Application	General Data	
Project Name: WestEnd / Landmark Block D	PC Hearing:	October 9, 2025
	CC Hearing:	October 18, 2025
	If approved,	October 18, 2028
Bandhark Brook B	DSUP Expiration:	000000110, 2020
	Plan Acreage:	63,315 SF (1.45 AC)
Location: 6025 Duke Street	Zone:	CDD #29 / Coordinated
		Development District #29
	Proposed Use:	Multi-unit residential
	Dwelling Units:	275
	Gross Floor Area:	362,254
Applicant: Landmark Land	Small Area Plan:	Landmark Van Dorn
Holdings LLC, c/o Foulger-		Corridor Plan
Pratt, represented by Kenneth Wire, Attorney	Historic District:	N/A
	Green Building:	LEED Silver or equivalent plus
		CDD #29 requirements

Consideration of a request to construct a residential building with 275 multifamily residential units.

Staff recommend **approving** Development Special Use Permit (DSUP) #2025-10020 to construct a new residential building on Block D, subject to Staff recommendations. This project conforms to the City's adopted plans, codes, and policies and provides several benefits for the community, including:

Figure 1: Block D Within the WestEnd Site

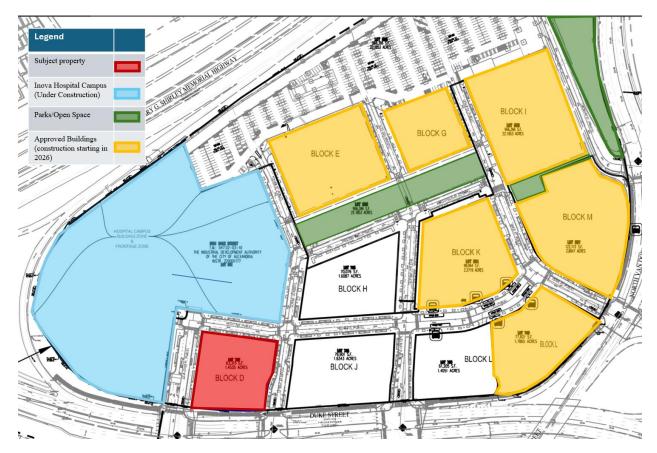
The applicant, Landmark Land Holdings, LLC, proposes to construct a new residential building with 275 rental units. Figure 1 shows Block D within the site. Key issues to consider, as discussed in greater detail in this report, include:

Figure 5: WestEnd Landmark Site-wide Open Space

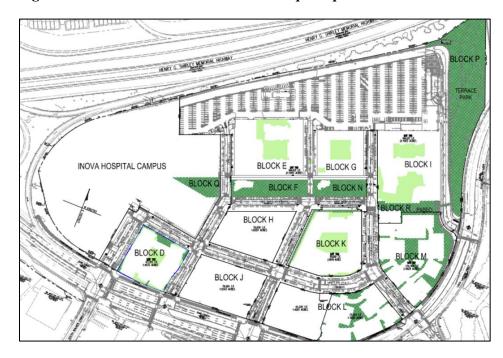
in Figure 4. The property is also one block south of the new Central Plaza and three blocks from the new paseo playground (see Figure 5).
